# UNITED STATES PATENT AND TRADEMARK OFFICE

10/776,851

**Office Action Summary**

## DETAILED ACTION

**FIG. 6****FIG. 7**

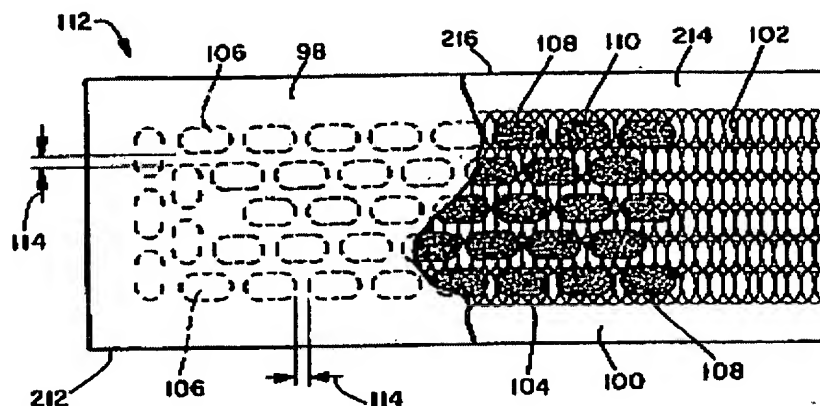
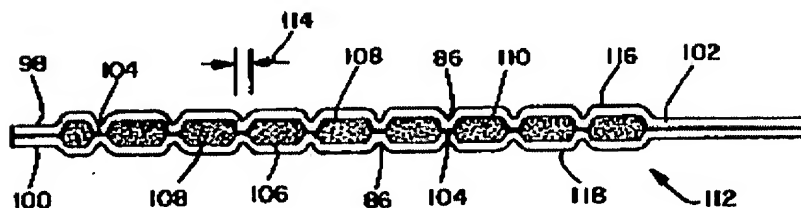
Regarding claim 1, Tanzer *et al.* teach an absorbent core (112, 120) useful for an absorbent article comprising a substrate layer (98) and absorbent material (110), said absorbent material (110) comprising an absorbent polymer material and *optionally* an absorbent fibrous material, said absorbent fibrous material not representing more than about 20 % of the weight of absorbent polymer material, wherein said absorbent material (110) is immobilized (trapped in

pocket regions (108)) when wet such that said absorbent core (112, 120) achieves a wet immobilization.

Tanzer *et al.* do not expressly disclose the specific degree of wet immobilization.
